LT-9284 Instructions for Installing DSPL-420RK

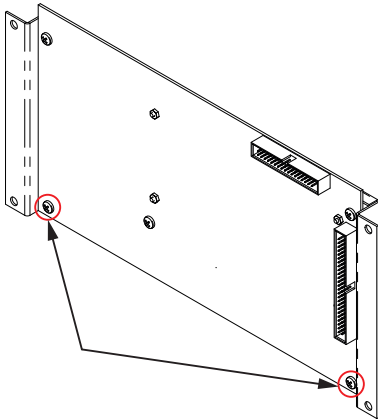
Some of the lower buttons on the main display of the FX-2000N may not be making contact. This is due to flexing of the circuit board behind these buttons. The DSPL-420RK retro-fit kit addresses this issue by providing a chassis (CH-1122) that is to be attached behind the main display. This prevents the circuit board from flexing and allows the buttons to make contact.

Note: There is a protective backing on one side of the CH-1122 chassis that protects the circuit board from the chassis. The CH-1122 must be installed in the orientation shown in order to protect the circuit board.

4. Place the CH-1122 chassis on the bottom of the printed circuit board and secure it using the screws removed in step 3.
